**Wichita-Sedgwick County Metropolitan Area Planning Department**  
March 9, 2009

**Re: BZA2009-08: Zoning Adjustment to reduce the side building setback from 10 feet to 5 feet adjacent to a platted reserve in SF-20 zoning for a covered deck expansion.**

**Lot 5, Block C Fountain Hills Addition to Sedgwick County, Kansas. Generally located north of Central and east of 127<sup>th</sup> Street East (660 N Preston Trail).**

RESIDENTIAL PLOT PLAN

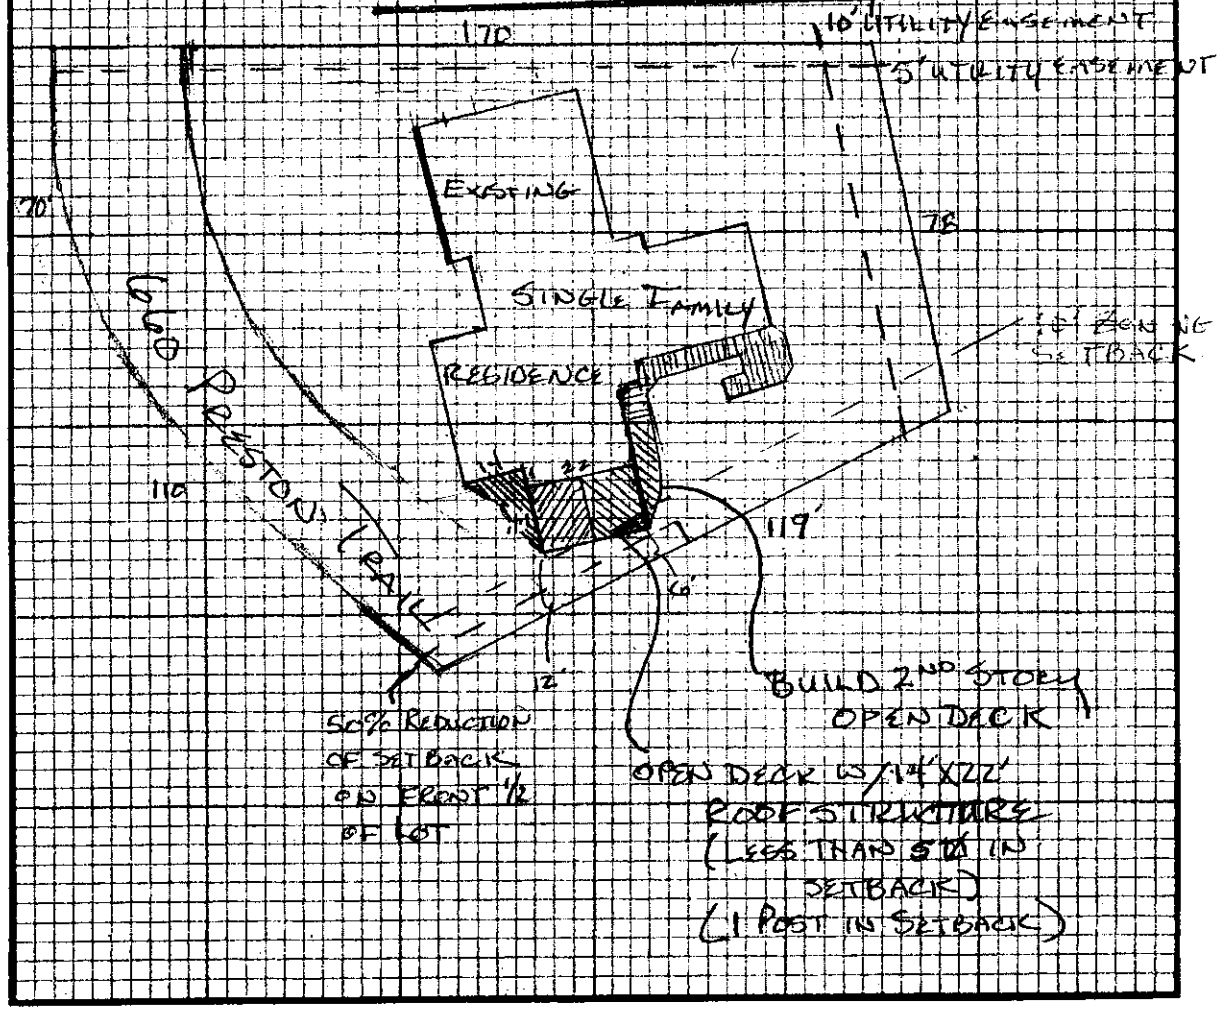
We have reviewed your request for a Zoning Adjustment to reduce the side setback for a deck addition on the aforementioned property. From reviewing the application, we understand that you desire to construct a deck within 5 feet of the south side property line, a 5 foot encroachment into the required 10 foot side building setback for the SF-20 zoning district. Therefore, you have requested an adjustment to reduce the required setback.

Section V-1.2.a. of the Unified Zoning Code allows the side setback to be reduced by 50% when the side yard borders a platted open space reserve, and when the provisions of that section and the Zoning Adjustment Criteria of Section V-1.6. are met. We find that the reduction of the side setback as proposed meets the provisions of Section V-1.2.a. and the four criteria required by Section V-1.6. as set out below:

Our signatures below indicate that a Zoning Adjustment to reduce the side setback for the aforementioned property from 10 feet to 5 feet is hereby granted, subject to the following conditions:

- 1) The site shall be developed in general conformance with the approved site plan.
- 2) The site shall be developed in conformance with all applicable codes, including but not limited to building, fire, and health codes.
- 3) The setback reduction shall apply only to the side setback as illustrated on the approved site plan. All other structures or additions on the subject property shall conform to the setbacks permitted by the Unified Zoning Code unless a separate Zoning Adjustment or Variance is granted.
- 4) If the Zoning Administrator finds that there is a violation of any of the conditions of the Zoning Adjustment, the Zoning Administrator, in addition to enforcing the other remedies set forth in the Unified Zoning Code, may, with the concurrence of the Planning Director, declare that the Zoning Adjustment is null and void.
